ADDENDUM NO. 4

**BOONE GROVE HIGH SCHOOL
RENOVATION AND RELATED WORK
Valparaiso, IN 46341**

ADDENDUM FOUR

Addendum Four (AD.04) to the drawings and specifications prepared by Gibraltar Design for **Boone Grove HS Renovation and Related Work** for Porter Township School Corporation, Valparaiso, Indiana.

UNIT "A" ELECTRICAL FIRST FLOOR DEMOLITION PLAN

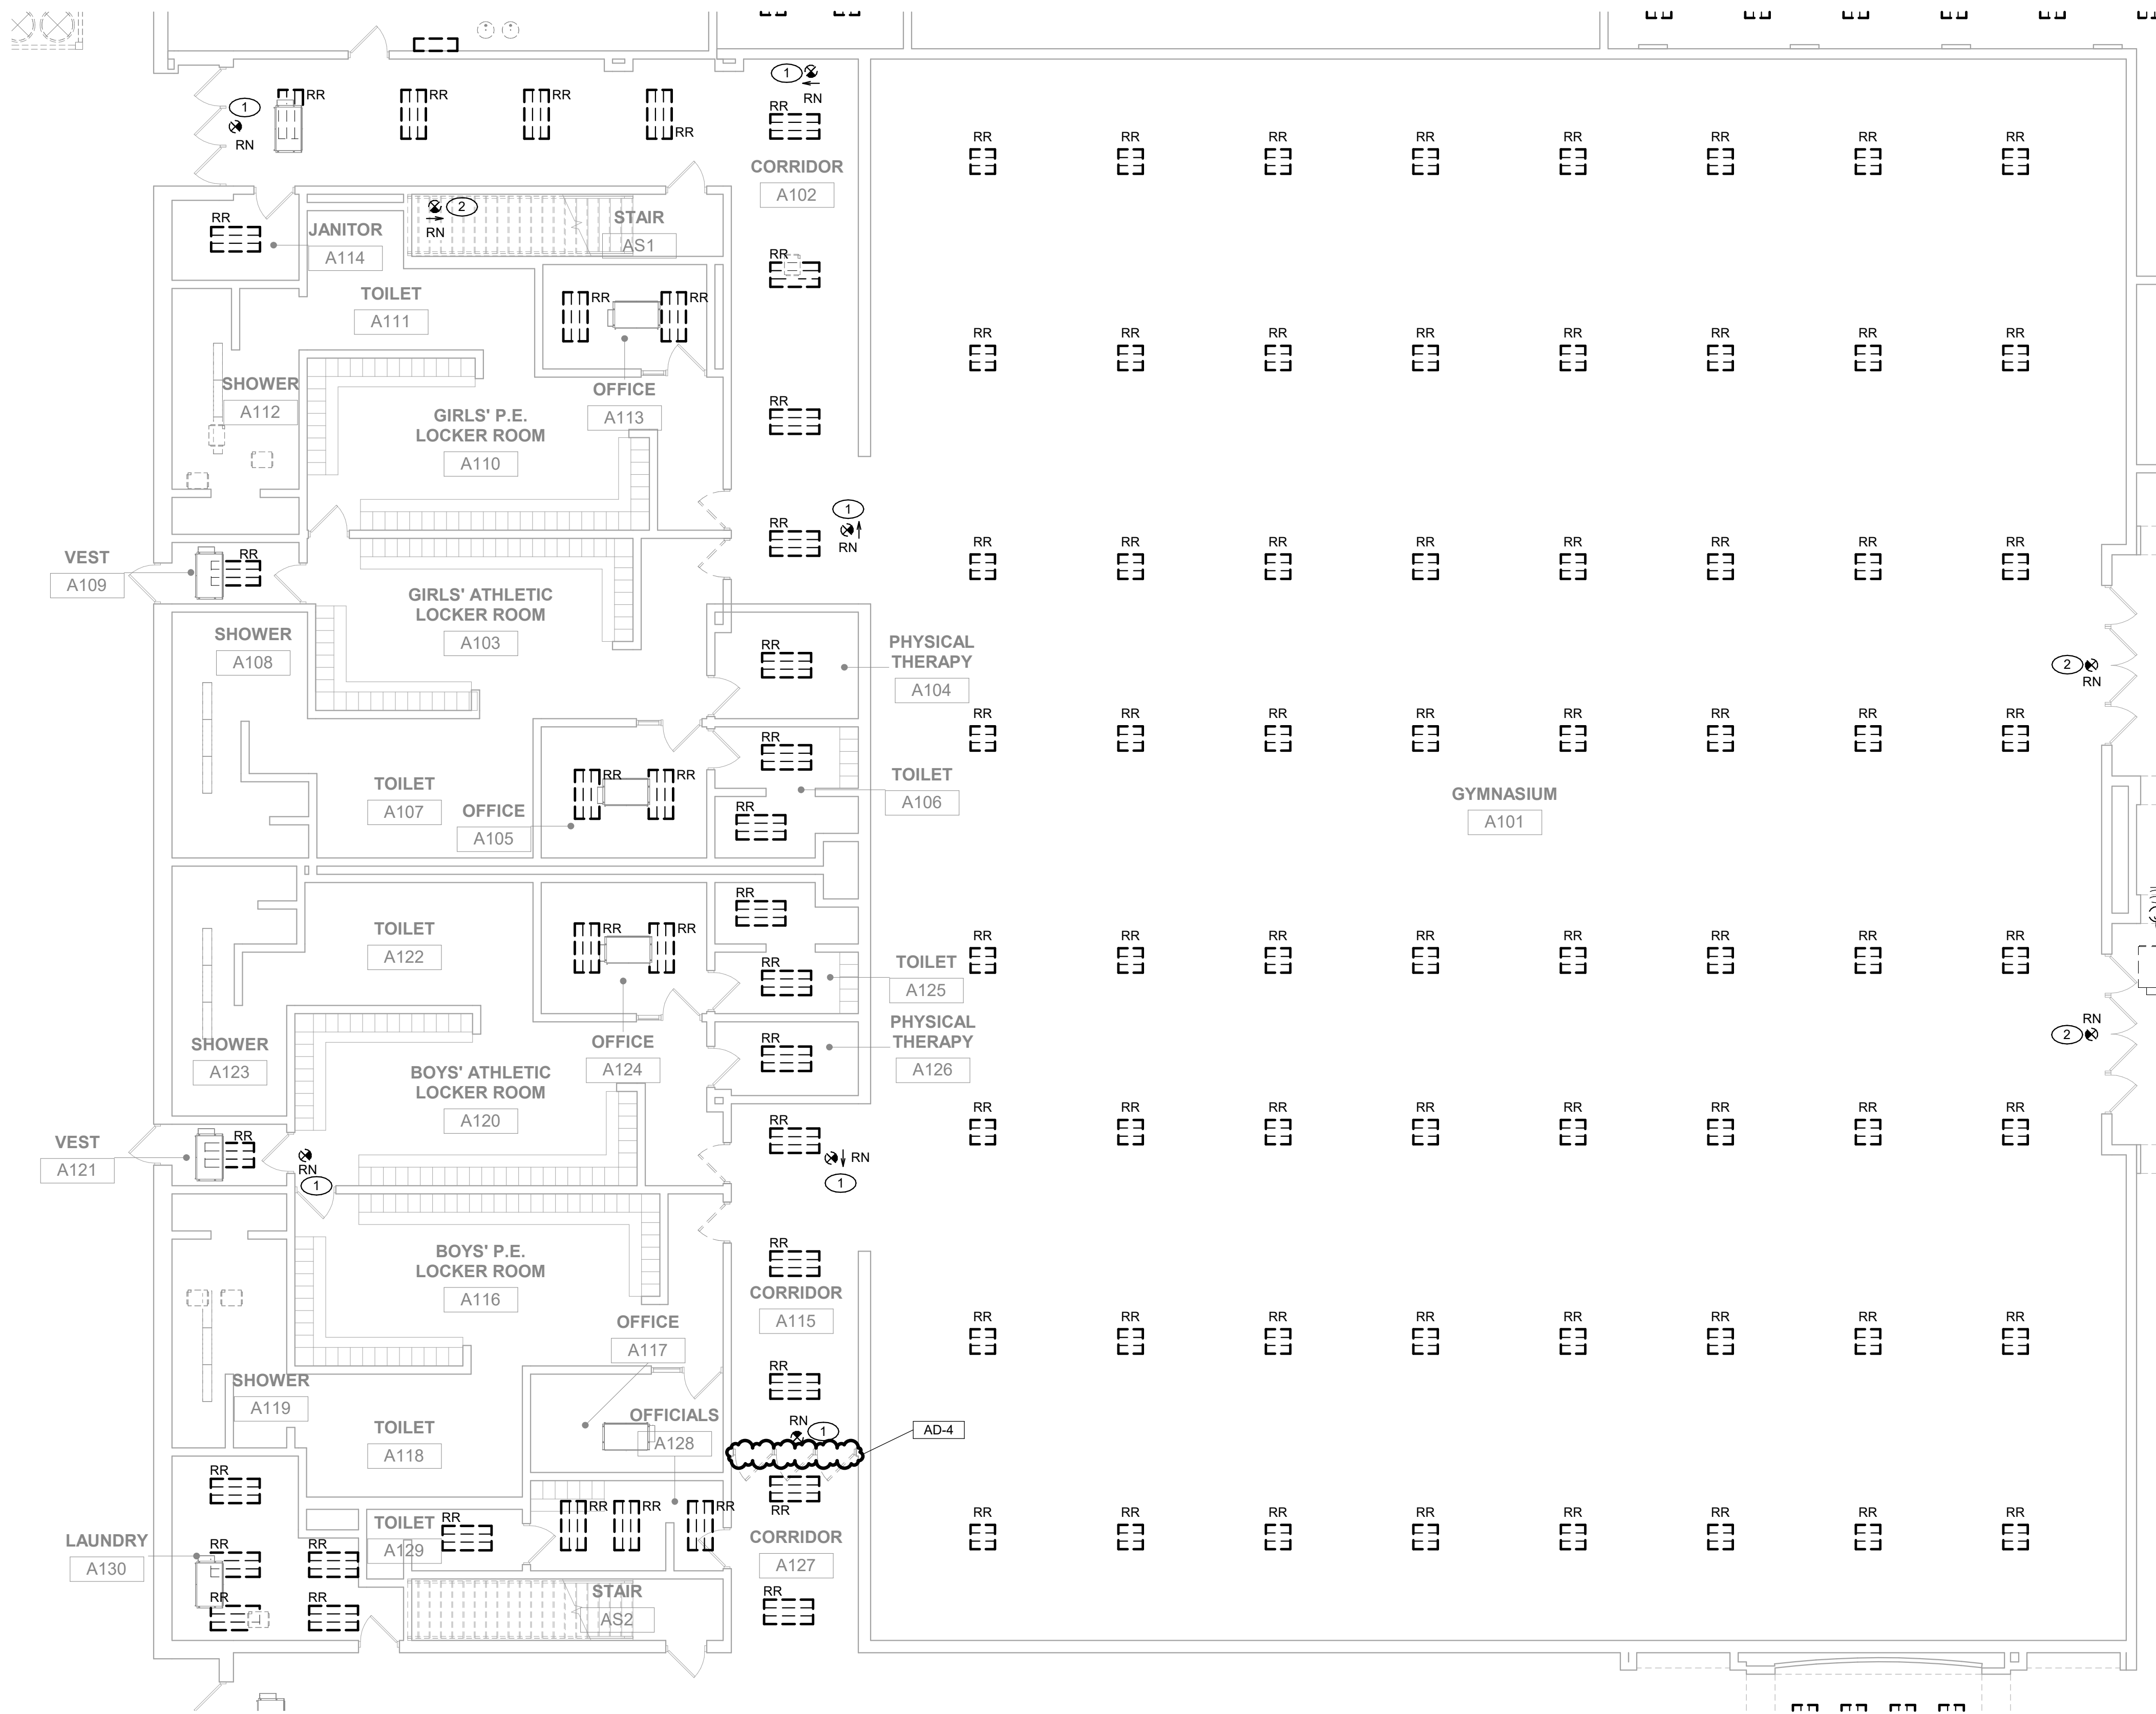
9. Sheet ED101

- A. Refer to revised, full-size drawing, included in this Addendum, for revisions.
 - 1. Clarification to existing conditions.

UNIT "B" ELECTRICAL FIRST FLOOR DEMOLITION PLAN

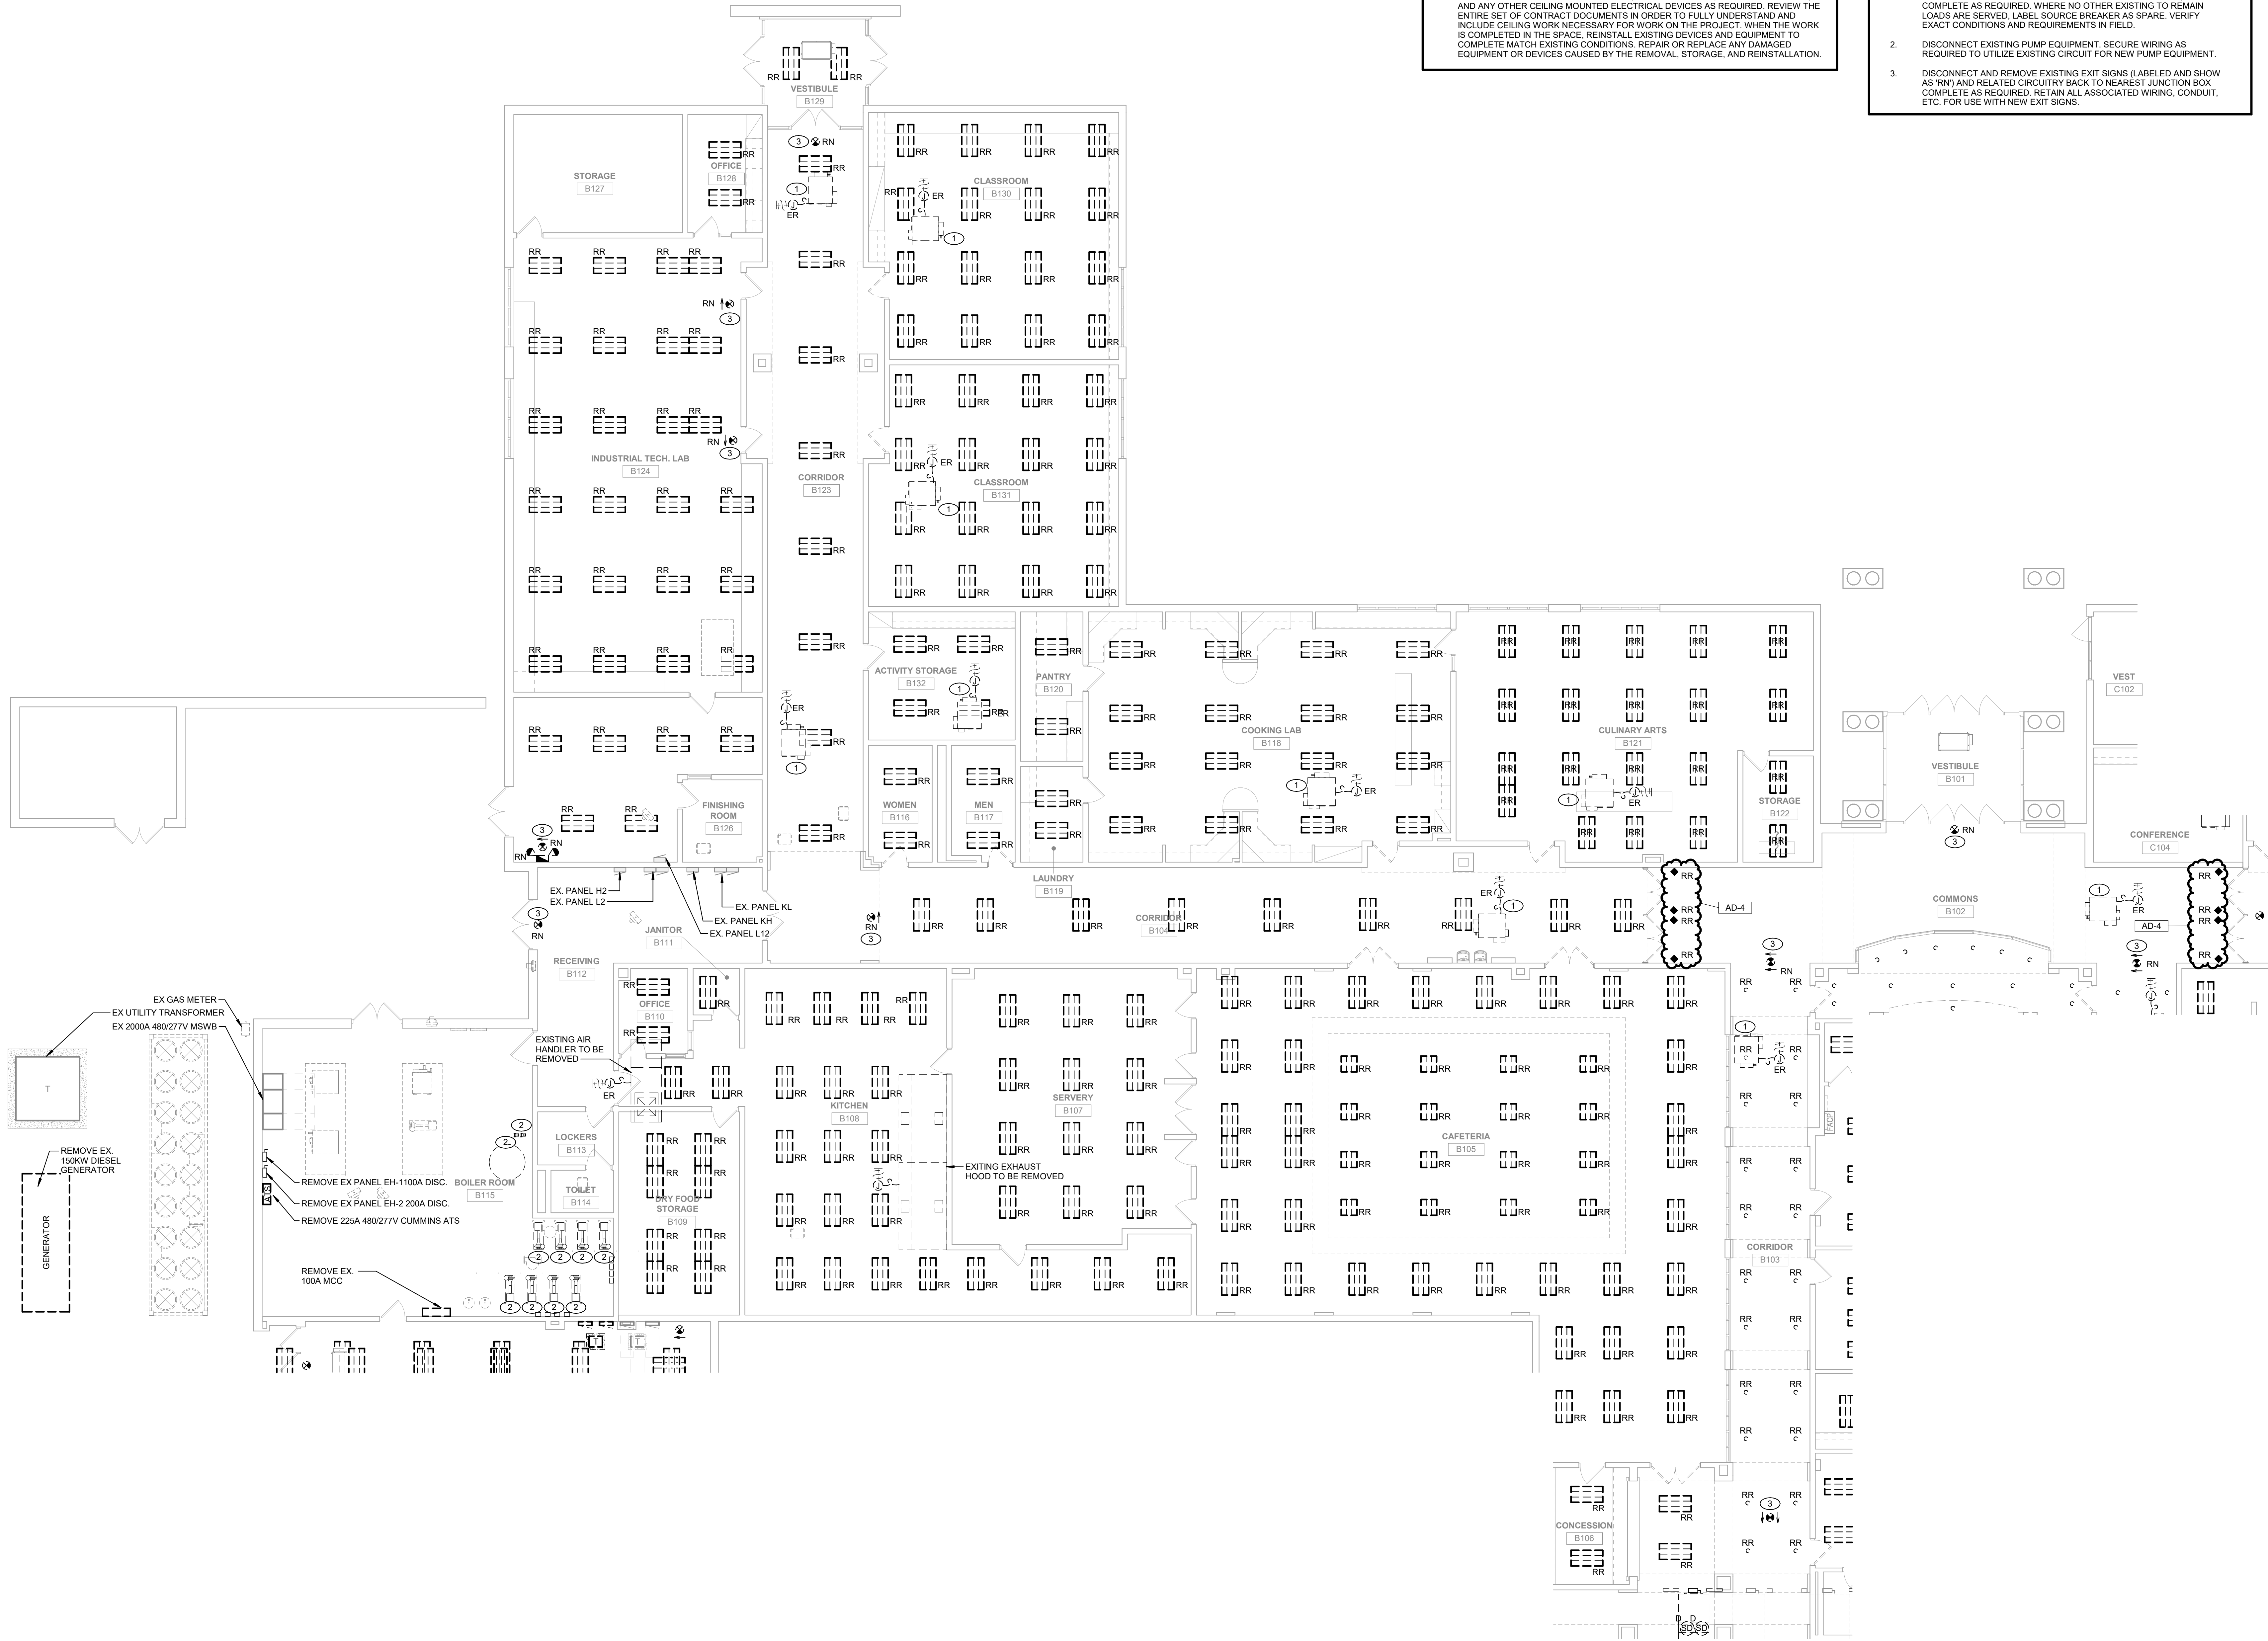
10. Sheets ED102 and ED104

- A. Refer to revised, full-size drawing, included in this Addendum, for revisions.
 - 1. Added items to be removed and relocated.

UNIT "A" ELECTRICAL FIRST FLOOR PLAN

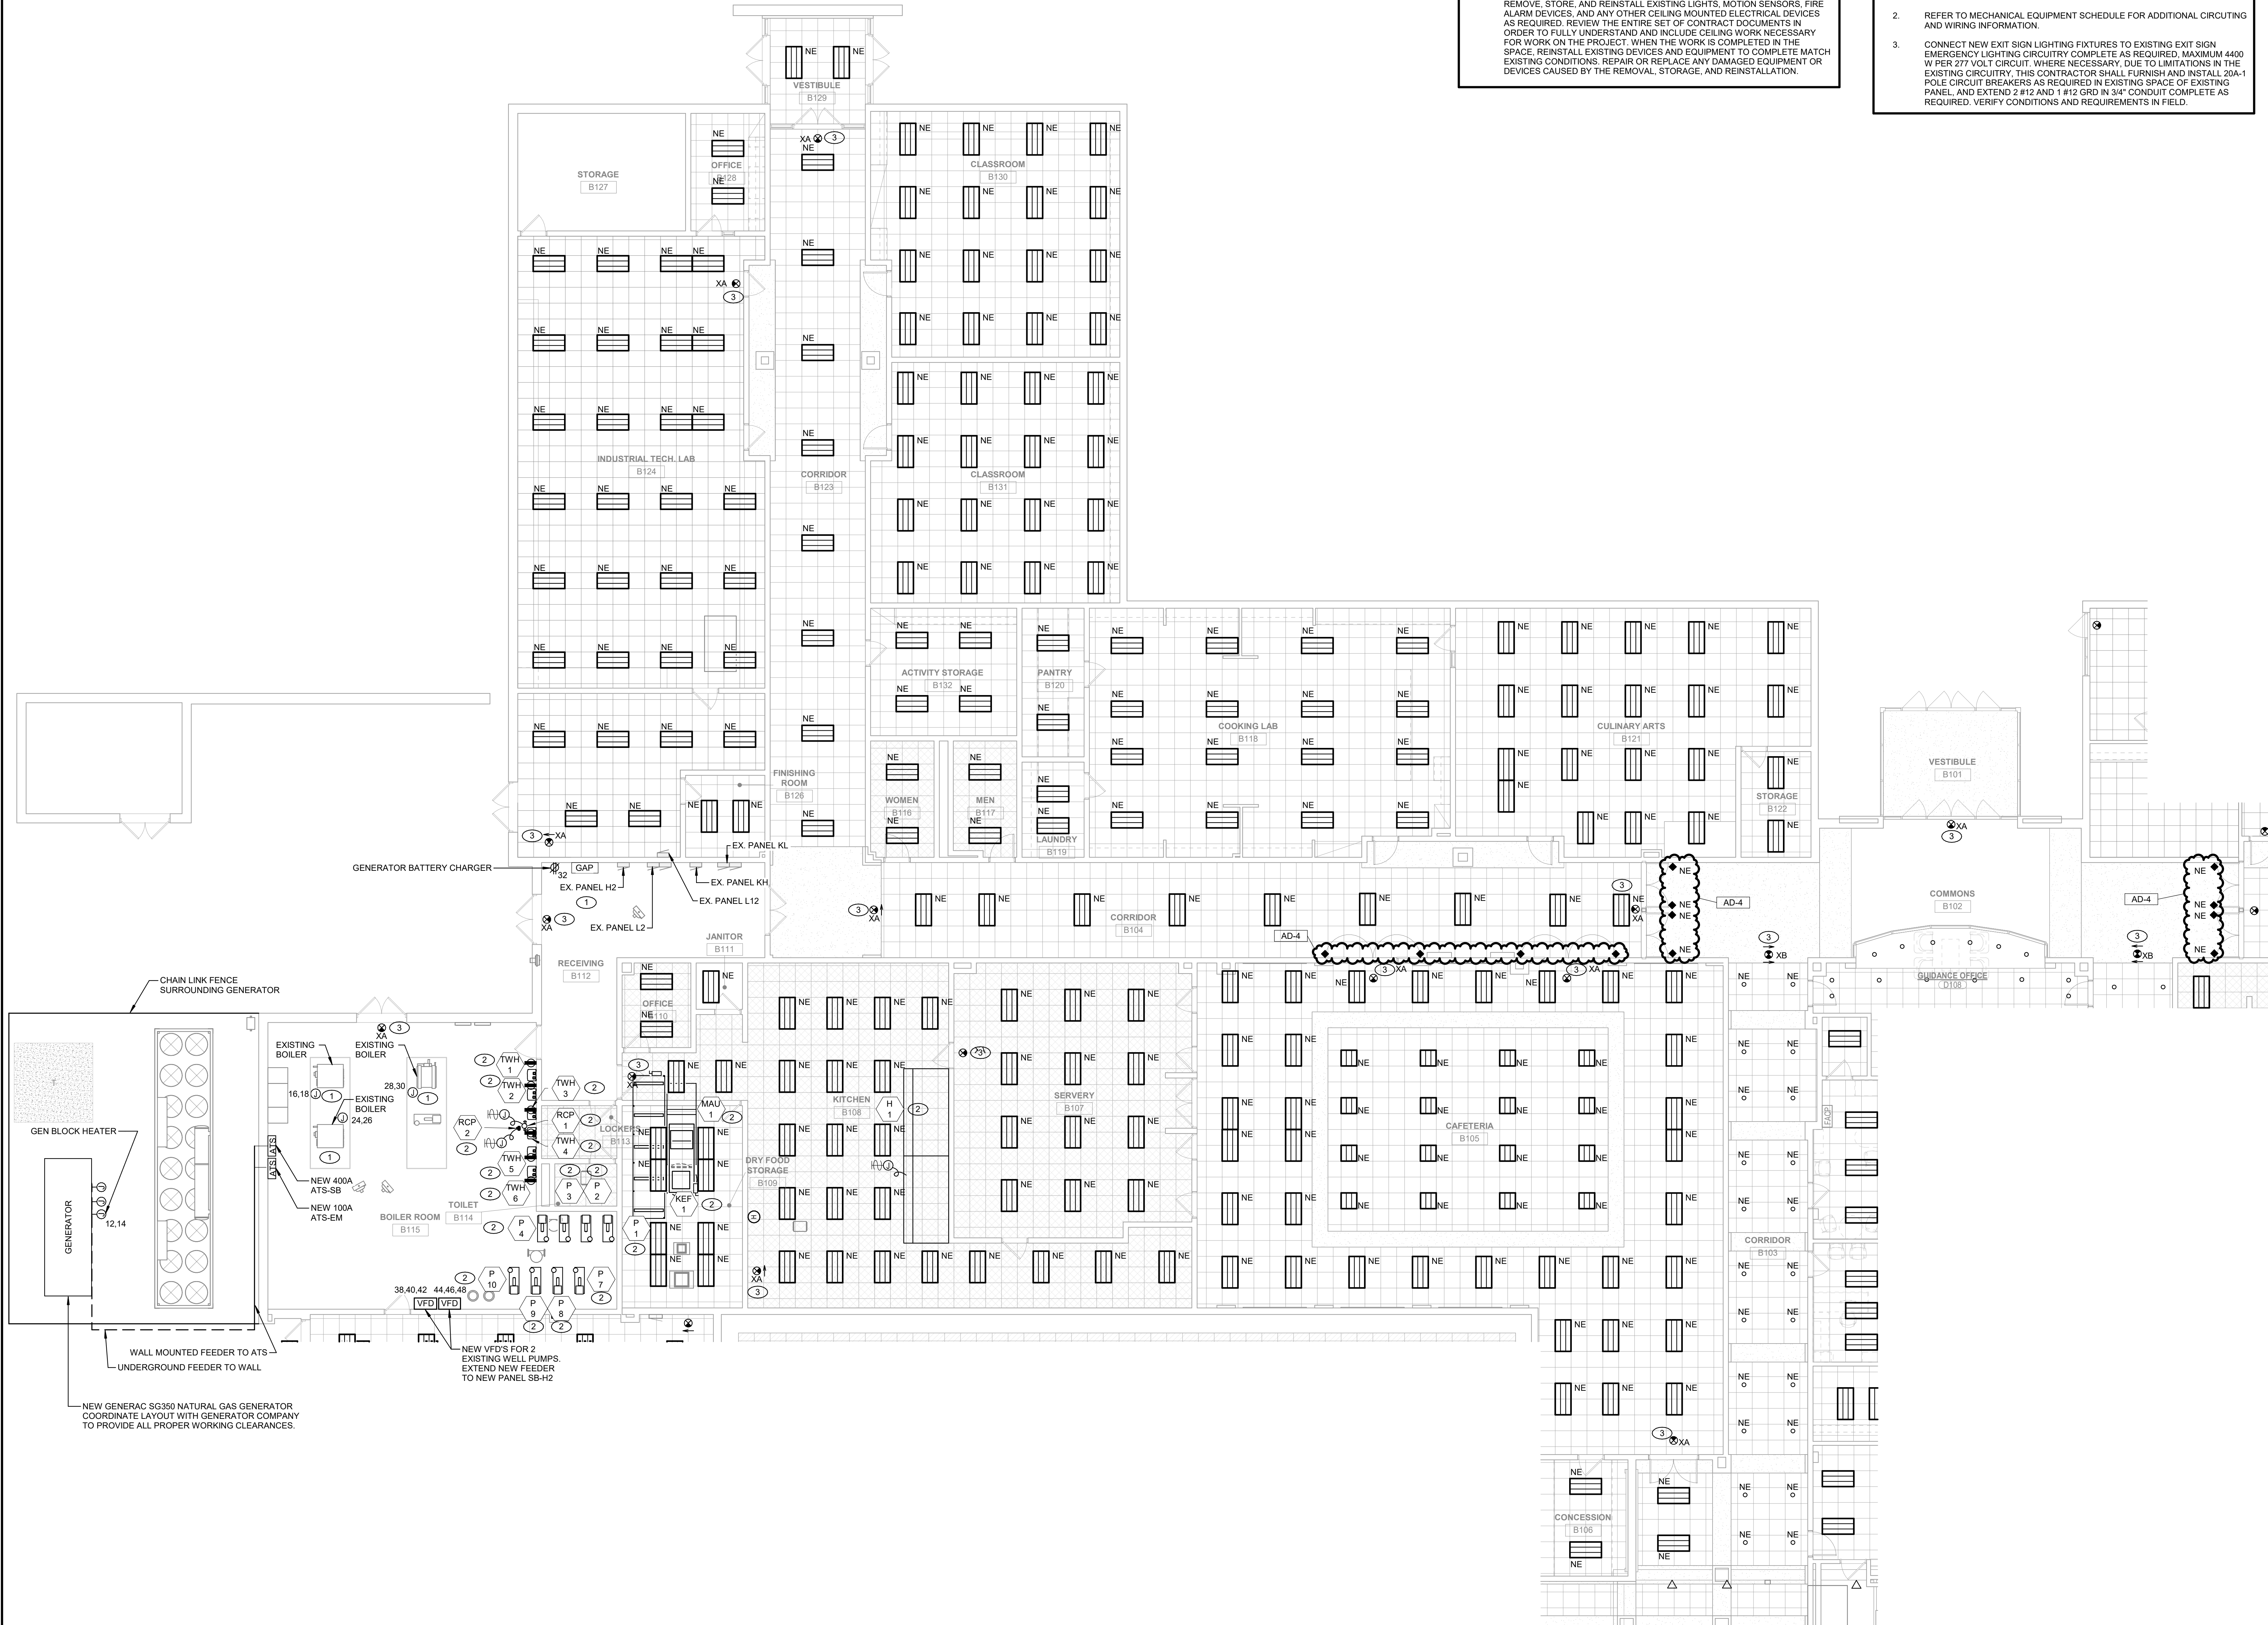
11. Sheet E-101

- A. Refer to revised, full-size drawing, included in this Addendum, for revisions.
 - 1. Added new electromagnetic door-holds to requested locations.
